81110A-05B

S E R V I C E N O T E

81100 Family Pulse Pattern Generators

**Intermittent display failures
(shifting lines, inverted, fully lit or completely dark display)**

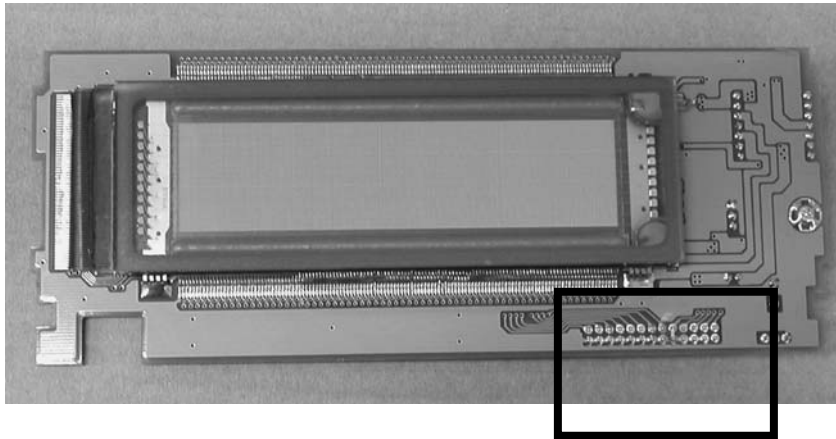
Intermittently the front panel display may show shifting lines that are falling back to their normal state. Additionally an inverted display, a display with all pixels lighted or a blank display may occur intermittently.

- Remove the front frame and unplug the connector cable from the 81100 mainframe.
- Carefully remove the display module from the front frame and check for a capacitor that might have been added during an earlier intermittent modification (see picture below). If there is such a capacitor, unsolder it from the module. Re-install the display into the front frame.

- On the 81100 mainframe replace the existing filter plate with the new filter plate, p/n 0960-0996. The new filter plate can be identified by a single connector pin that shows a red color code.
